PROJECT:  
STAGE 5 - CLUB EXTENSION

PROJECT:  
STAGE 5 - CLUB EXTENSION  
PHASE 2 WORKS - SOUTHERN  
CARPARK & ENCLOSURE

DRAWING TITLE:  
PROPOSED ELEVATIONS

SECTION 96

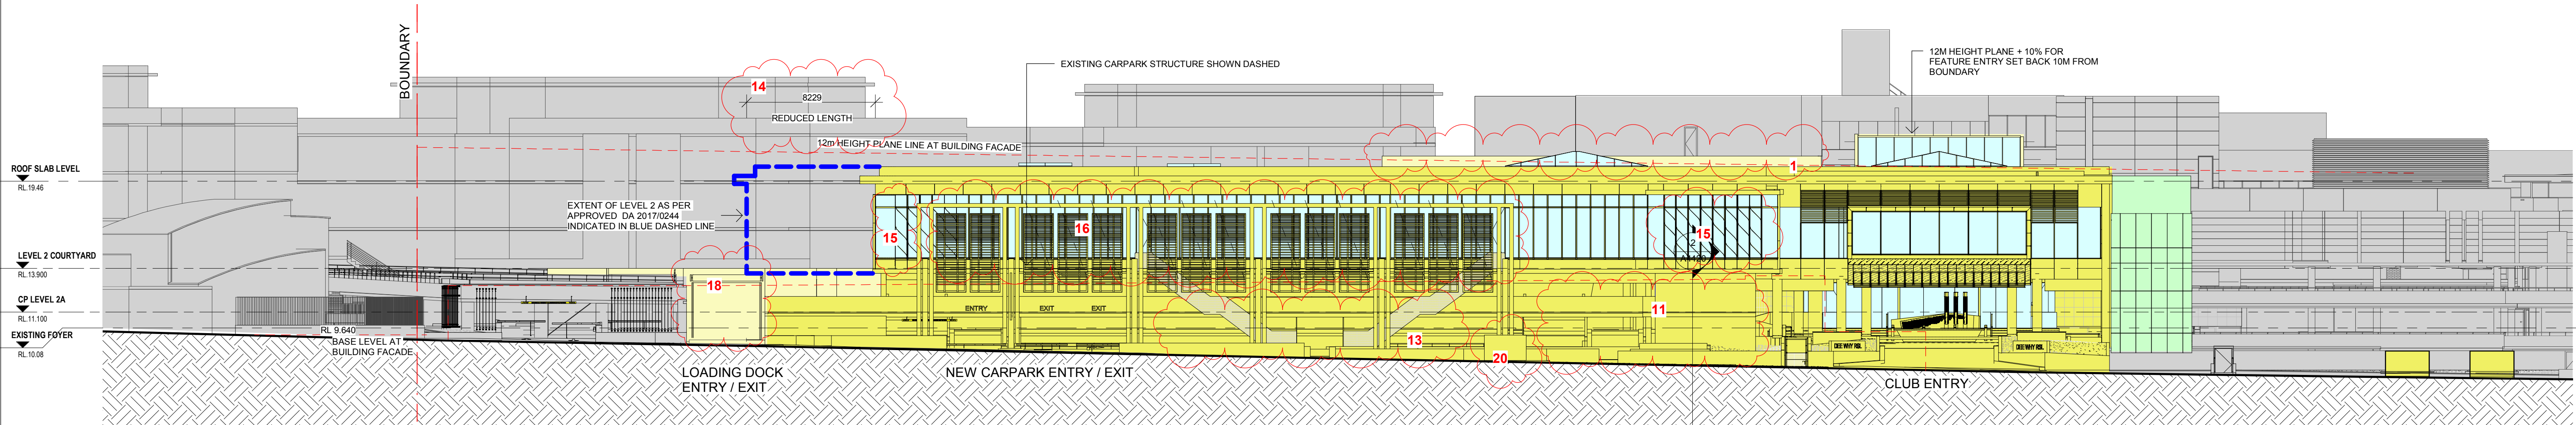
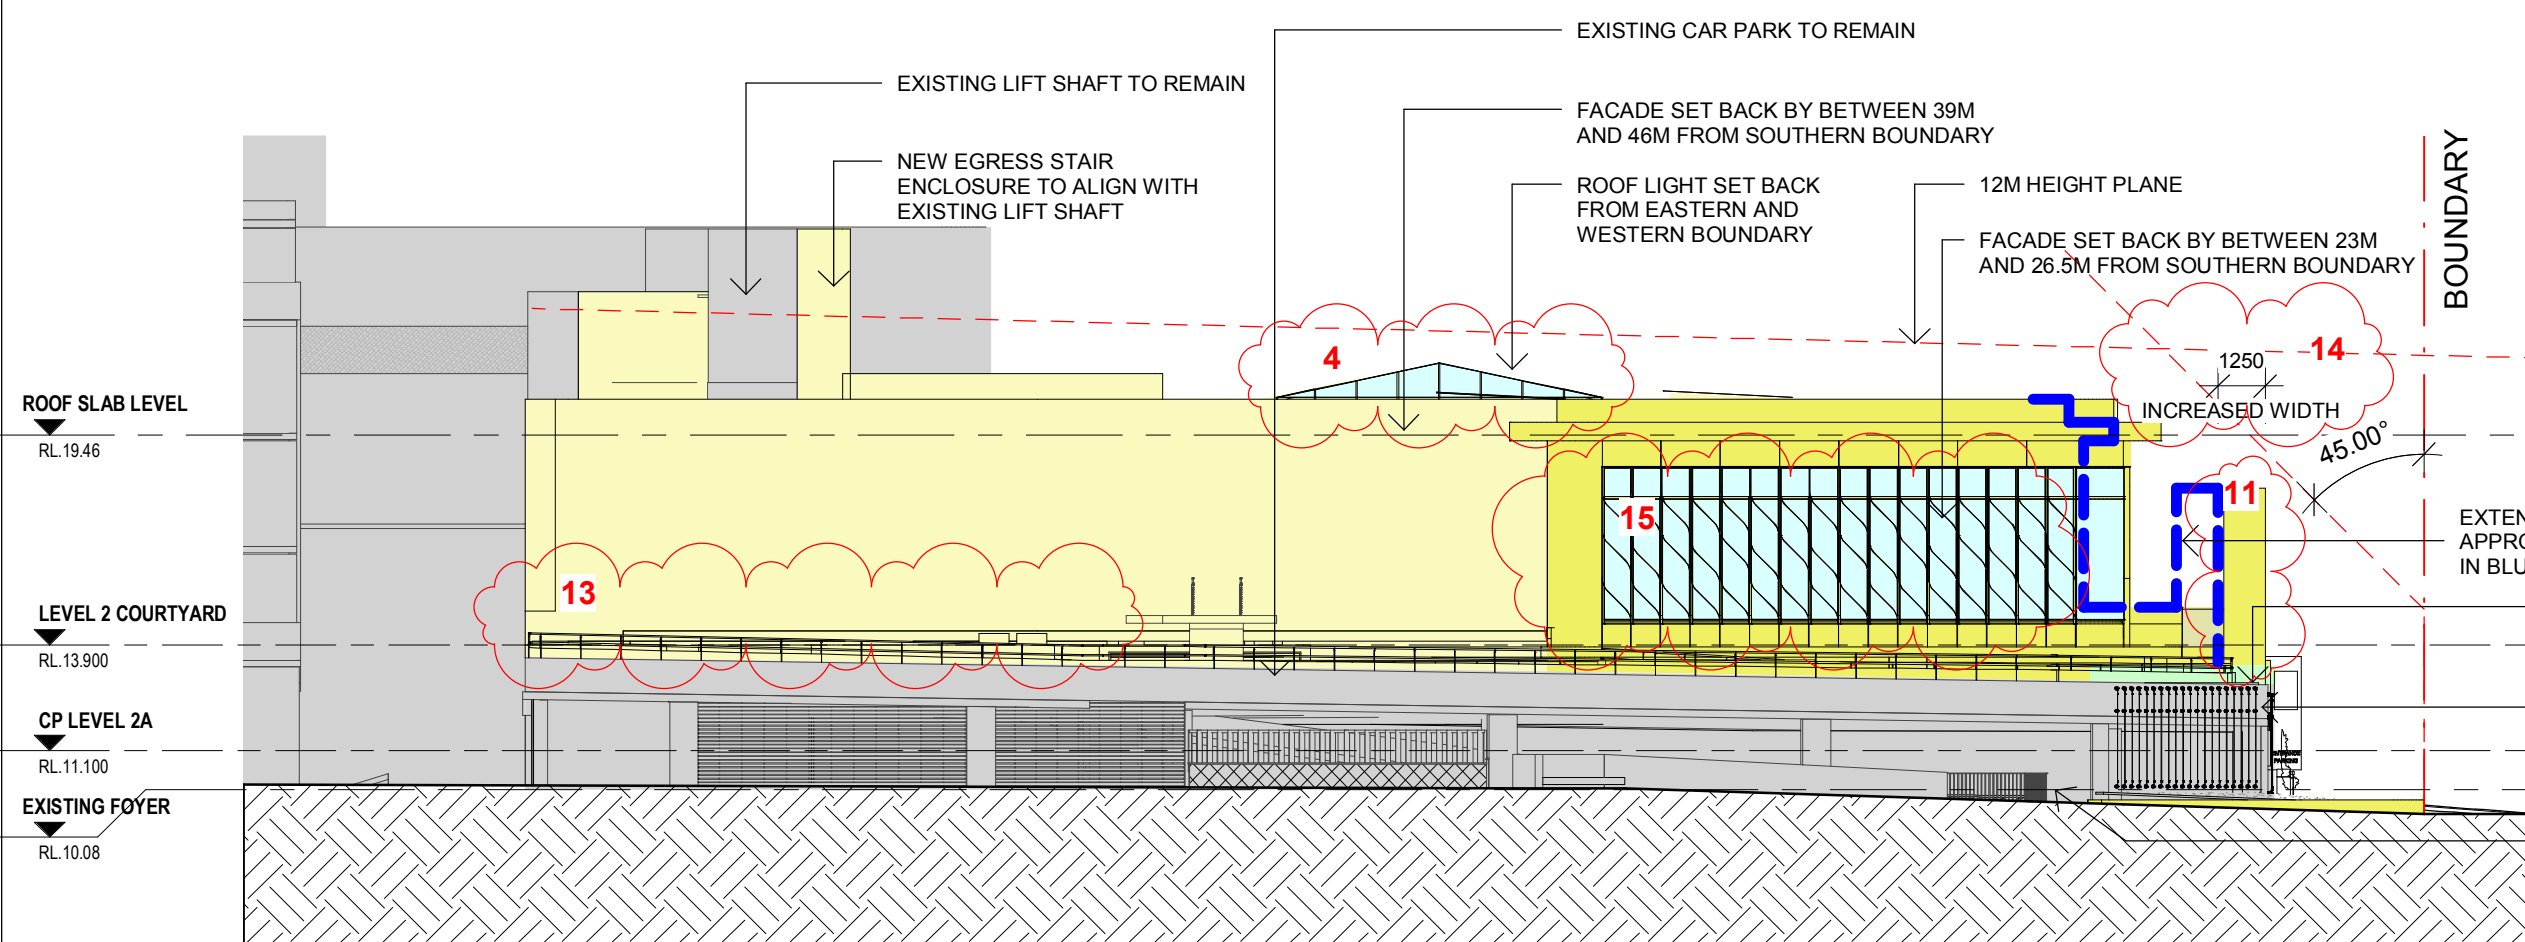
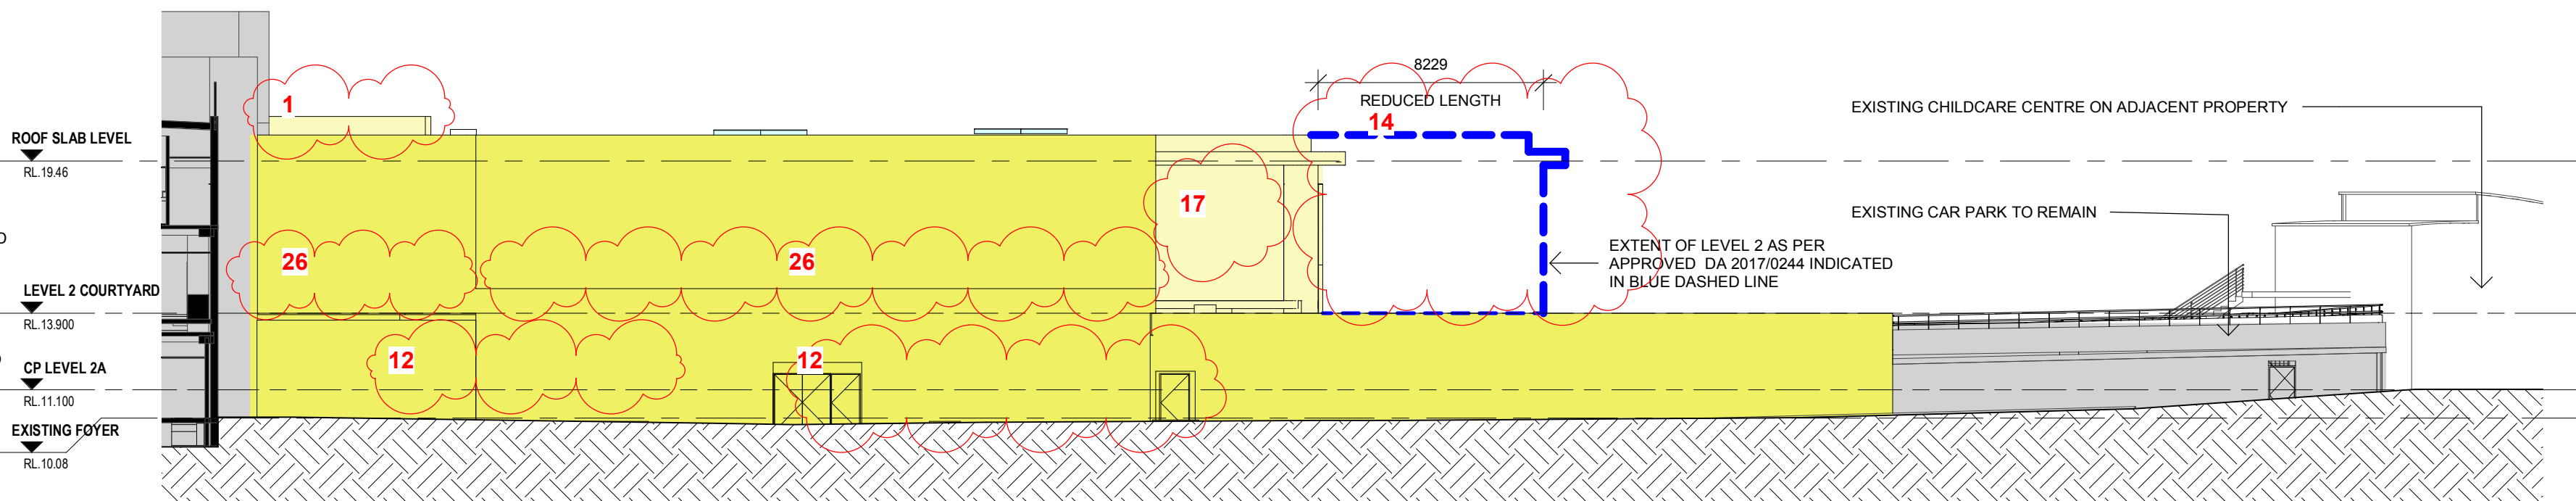
- CHANGES FOR SECTION 96 APPROVAL
- roof
1. RELOCATED OPEN PLANTROOM AT THE ROOF LEVEL
  2. MODIFIED ROOF OPENING ABOVE MAIN ENTRANCE
  3. MODIFIED CENTRAL SKYLIGHT (REDUCED HEIGHT, MODIFIED PITCH)

4. MODIFIED COURTYARD: TWO OPEN COURTYARDS AND ONE SKYLIGHT COVERED AREA INSTEAD OF ONE LARGE GLASS ROOF. REDUCED HEIGHT AND PITCH
  5. MODIFIED SMOKING TERRACE: ROOF OPENING, SIZE AND PLANTED AREA. AREA REDUCED BY 21m<sup>2</sup>

6. REDUCED NUMBER OF ROOF SKYLIGHTS ABOVE ASIAN RESTAURANT: 2 INSTEAD OF 6 TO SUIT THE NEW INTERNAL LAYOUT
  7. MODIFIED EXIT STAIR: POSITION, CONFIGURATION, METAL ROOF NO LONGER REQUIRED

8. CONCRETE ROOF INSTEAD OF METAL DECK ROOF FOR THE MAJORITY OF THE BUILDING EXTENSION
  9. NO SLAB ABOVE THE EXPOSED CAR PARK LEVEL 2 IN THE SOUTH AREA

10. NEW ACOUSTIC METAL ROOF ABOVE REVISED LOADING DOCK
- facade
11. MODIFIED FACADE APPEARANCE DUE TO CHANGES IN THE CAR PARK LEVELS, LOADING DOCK AND EGRESS STAIRS

12. REMOVED LOUVRES ON THE BACK FACADE (WESTERN FACADE) DUE TO MECHANICAL RISER NO LONGER REQUIRED / REVISED LOCATION FOR EGRESS DOORS
  13. 2m WIDE INTERNAL EGRESS STAIR MODIFIED INTO TWO 1m WIDE EXTERNAL STAIRS WITH DECORATIVE BALUSTRADES

14. EXTENT OF LEVEL 2 (MAIN TRADING LEVEL) REDUCED BY 8320mm FROM THE SOUTHERN BOUNDARY AND INCREASED BY 1100mm TO THE EASTERN BOUNDARY
  15. MODIFIED FACADE CURTAIN WALL MULLION BLADES

16. CONCRETE BLADE WALL REDUCED BY 1.47m IN HEIGHT AND 6.2m IN LENGTH
  17. VERTICAL FINS REMOVED FROM BACK WALL (WESTERN FACADE)
- ground/landscape/floor plate

18. REVISED LOADING DOCK ENTRANCE AND LOCATION/ ENLARGED DEMOLISHED AREA IN THE EXISTING RETAINED SOUTHERN CAR PARK
  19. NEW / MODIFIED EGRESS PATHS FROM EXISTING CARPARK LEVEL -1. NEW CARPARK LEVEL 1.

20. RELOCATED ELECTRICAL SUBSTATION / LANDSCAPED AREA MOVED TO SUIT
  21. MEDIAN STRIP ADDED AT ENTRY TO PROVIDE PLACE OF REFUGE AND ENSURE WIDTH OF ENTRY/ EXIT IS LESS THAN 8M AS PER DA CONDITION 23

22. RELOCATED STORMWATER OVERFLOW PATH
  23. EXTENT OF BASEMENT CAR PARK LEVELS REDUCED. BASEMENT REDUCED BY 14394mm FROM THE WEST BOUNDARY. BASEMENT ENLARGED BY 280mm TOWARDS THE SOUTH BOUNDARY. CARPARK CHANGED FROM FLAT PLATE TO SPLIT LEVEL ON ALL LEVELS. DEPTH OF CAR PARK INCREASED FROM RL - 3.600 TO RL -5.700. OVERALL PARKING SPACES REDUCED FROM 687 TO 680

24. BASEMENT CAR PARK LEVEL -5 ADDED.
  25. CAR PARK ENTRY / EXIT MOVED TOWARD NORTH BY 30444mm
  26. PLANTER MODIFIED ON THE BACK (WESTERN) FACADE DUE TO REDUCTION OF THE MAIN TRADING FLOOR SLAB

27. LOCATION OF AIR INTAKE MODIFIED
  28. EXTENT OF RESTAURANT REDUCED BY 136m<sup>2</sup>
  29. CLUB ENTRANCE ACCESSIBLE RAMPS MODIFIED
  30. ONE ADDITIONAL EXISTING CAR PARK SPACE TO BE REMOVED FROM EXISTING NORTHERN CAR PARK

31. SOLID MASONRY WALL ADDED BETWEEN EXISTING ZONE D CAR PARK AND LOADING DOCK ACCESS.
